Remarks/Arguments

This Amendment is filed in response to the Office Action dated January 28, 2005. Applicants thank Examiner Peng for the thorough examination of Applicants' invention.

Amendments of the Drawings

FIG. 1A

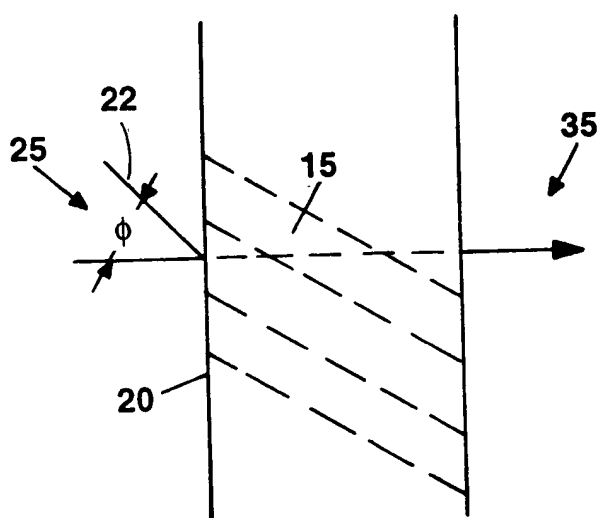
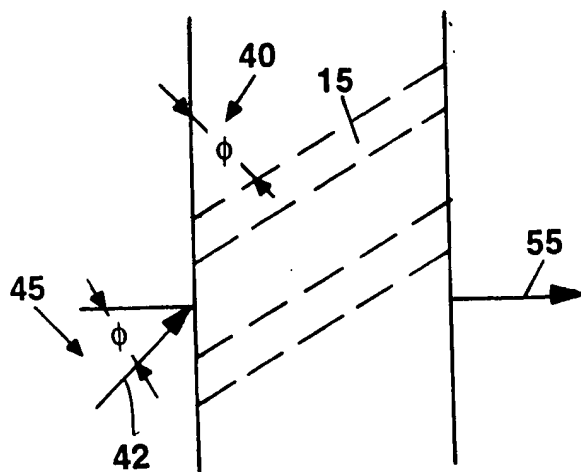
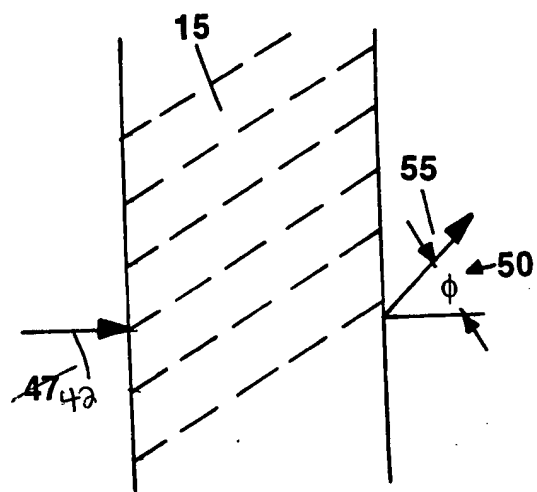
The attached 9 sheets of drawings includes changes to Figs. 1A, 1C, 1D, 4A, 4B, 7, 8, 11 and 12. These 6 sheets, replace the original 6 sheets. It is noted that sheet 2 is not included because there are no amendments on this sheet. In Figures 1A, 1C and 1D, lead lines have been added for clarity; in Figure 1D, the input beam labeled 47 has been relabeled to the correct number 42 (as referred to and described in the specification), and a "Prior Art" label has been added. In figure 4A and 4B, previously omitted labels (referred to and described in the specification) 303 and 360 have been added. In Figure 7, previously omitted label (referred to and described in the specification) 440 has been added, as requested by the Examiner. In Figure 8, previously omitted labels (referred to and described in the specification) 660, 670 and 680 have been added as requested by the examiner, label 615, which is not referred to in the specification, is deleted and labels 611, 612, 613, 614 have been moved in order to render the elements indicated consistent with the specification. In Figure 11, previously omitted label (referred to and described in the specification) 800 (referred to and described in the specification) has been added. In previously submitted Figure 12, the image was shifted from copying; this has been corrected. No new matter is added due to the above amendments; support for any new elements in the drawings can be found in the specification drawing descriptions.
